**Contact No. 142** Selected S Toggles, LW & SW Rockers, SB Pushbuttons

## Change Notice

# Terminal Plating from Silver to Tin

### Terminal Surface Finish

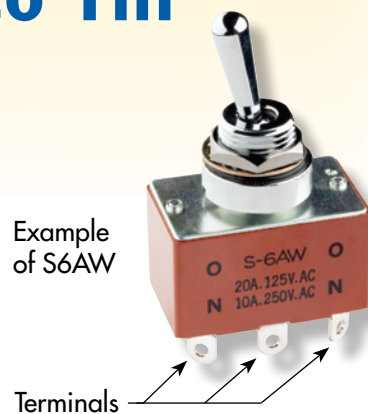
- Provides greater resistance to environmental conditions
- Inhibits tarnishing, extending storage properties

FROM	TO
Anti-Tarnishing Silver (Ag) Plating	Tin (Sn) Plating over Copper (Cu) Plating
